ADDENDUM #1

Reference: Dental Lab Improvement
Utah Valley University – Orem, Utah
Project No.10027790

Addendum No. 1

Project:	Dental Lab Improvements	Date:	28 April 2010
Address:	987 S. Geneva Rd.	Project No.:	DFCM 10027790 / HFSA 1011.01
City, State:	Orem, Utah 84058	Institution:	Utah Valley University

B3 CMU INFILL WALL CONNECTION
SCALE: 1 1/2" = 1'-0"

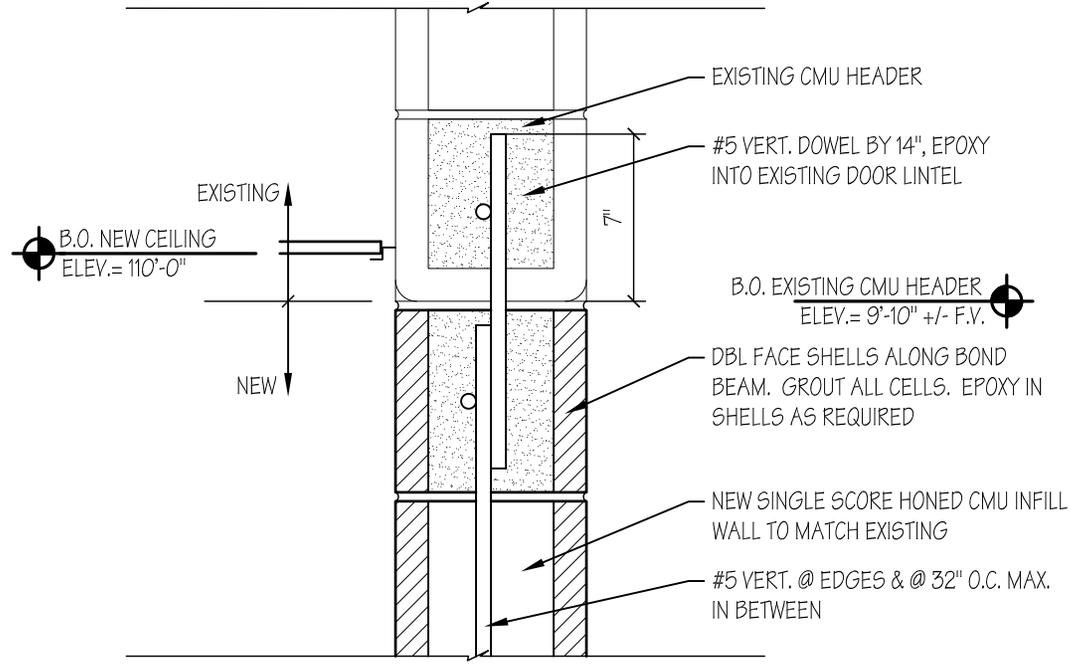
1-19	AD101	At exterior Pump room west of grid F-7 and north of grid 14.6, add a note: "See note 12 on sheet P101"
1-20	AD101	Add note that "New sink drain lines require additional slab saw cutting, trenching, backfilling and capping with concrete- See P101 for extent"
1-21	AD101	5' north of grid 14.6 and 2' west of grid F-5 is a fire extinguisher and cabinet. Remove and relocate into new CMU wall on grid F-5 north of grid 14.6.
1-22	AE101	At exterior Pump room west of grid F-7 and north of grid 14.6, add a note: "See note 12 on sheet P101"
1-23	AE101	Add note that "New sink drain lines require additional slab saw cutting, trenching, backfilling and capping with concrete- See P101 for extent"
1-24	AE101	Add section cut C2/AE601 on grid F-7 between grids 14.5 and 14.6. This detail is attached at the end of this addendum.
1-25	AE101	At the infill wall on grid F-5 to the north and south of grid 14.6 add floor connection detail A4/AE601, head connection detail B4/AE601, wall connection detail B3/AE601 and column connection detail A3/AE601. These details are attached at the end of this addendum.

B4 CMU INFILL HEAD CONNECTION
 SCALE: 1 1/2" = 1'-0"

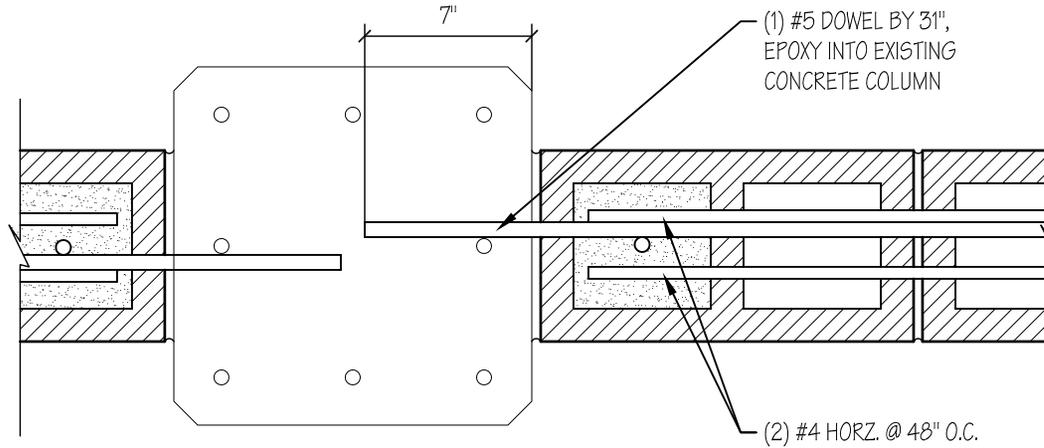
Item No.	Section or Sheet No.	Description
1-29	AE401	Detail D\$: Add note to "drill counter for 1 grommet every 3' and provide grommet
1-30	AE601	Detail C5/AE601: Delete "hardwood base"- bast to be 4" coved rubber base
1-31	AE601	Detail B4/AE601: 1 st course is black "Spectra Glaze" CMU, above that is single score honed lightweight block.
1-32	P101	In Lab 126, the sink shall be changed from 'S-2' to 'S-3'.
1-33	P101	In Sterilization 125, the sink shall be changed from 'S-3' to 'S-4'.
1-34	P101	At all sinks 'S-1' and 'S-2' where the vent is to terminate in an air admittance valve, this valve is to be located adjacent to the sink, immediately below the countertop (valve must be 4" above the fixture drain).
1-35	P101	Note 11 shall be deleted and changed to read, "PROVIDE AIR ADMITTANCE VALVE ADJACENT TO THE SINK IMMEDIATELY BELOW THE COUNTER-TOP".
1-36	FP101	The "Symbol List" shall be changed: All sprinkler heads shown as existing in place, existing to be moved, or new shall now all be new heads.
